In support of I-37, I-80, I-81, I-84, I-86, I-87, I-90 proposed resolution

Sept 15, 2020

IEEE P802.3cu 100 Gb/s and 400 Gb/s over SMF at 100 Gb/s per Wavelength Task Force

Figure 140–5—Illustration of receiver sensitivity

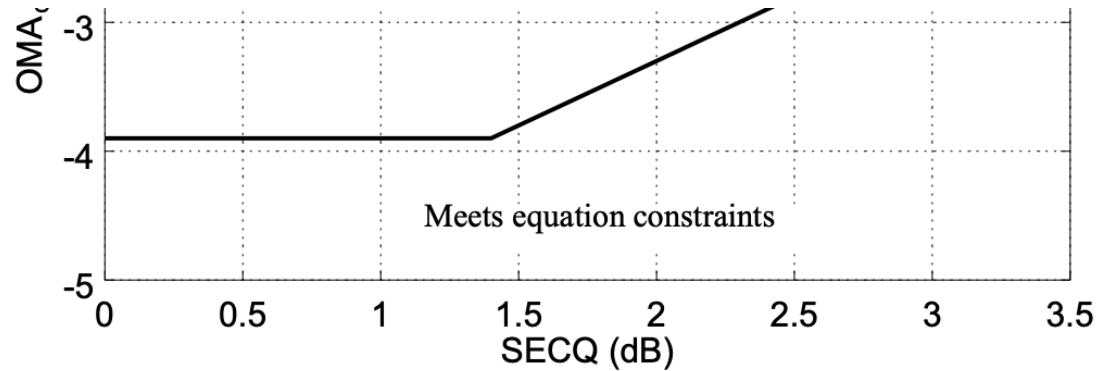
Cl 140 SC 140.7.9 P51 L15 # I-80

Here, the penalty in the signal for RS testing is called SECQ, while in 140.6.3 and p52 line 7 it's TECQ. Rule says use the same name for the same thing, every time.

Options are:

Change to SECQ to align with base document. Consider repurposing SECQ to "signal eye closure (quaternary)"; or

Define ECQ "eye closure (quaternary)" for general use including when it's not necessarily of transmitted signal at TP2 (TECQ), dispersed signal at TP3 (TDECQ), or stressed signal at TP3 (SECQ).

100GBASE-DR receiver sensitivity is based on SECQ and changing it to TECQ for consistency with 100GBASE-FR1 and 100GBASE-LR1 is out of scope.

The three new paragraphs starting at page 52, line 1, apply to 100GBASE-FR1 and 100GBASE-LR1 only. The draft could be improved to make this clearer. A presentation is expected.

Insert a new subclause heading 140.7.9.1 to contain the existing text and figure from 140.7.9 as follows:

140.7.9.1 Receiver sensitivity for 100GBASE-DR

Change the content of 140.7.9.1 (formerly the content of 140.7.9) as follows:

The rReceiver sensitivity for 100GBASE-DR is informative and is defined for a transmitter with a value of SECQ up to 3.4 dB. Receiver sensitivity for 100GBASE-DR should meet Equation (140–1), which is illustrated in Figure 140–5. The normative requirement for the 100GBASE-DR receiver is stressed receiver sensitivity.

Insert a new subclause 140.7.9.2 as follows:

140.7.9.2 Receiver sensitivity for 100GBASE-FR1 and 100GBASE-LR1

The receiver sensitivity (OMA_{outer}) for 100GBASE-FR1 and 100GBASE-LR1 shall be within the limits given in Table 140–7 if measured using a test pattern for receiver sensitivity in Table 140–10.

The conformance test signal at TP3 meets the requirements for a 100GBASE-FR1 or 100GBASE-LR1 transmitter followed by an attenuator.

The TECQ of the transmitter used to measure the receiver sensitivity is measured according to 140.7.5, except that the test fiber is not used. The measured value of TECQ is then used to calculate the limit for receiver sensitivity (OMA_{outer}) as specified in Table 140–7.
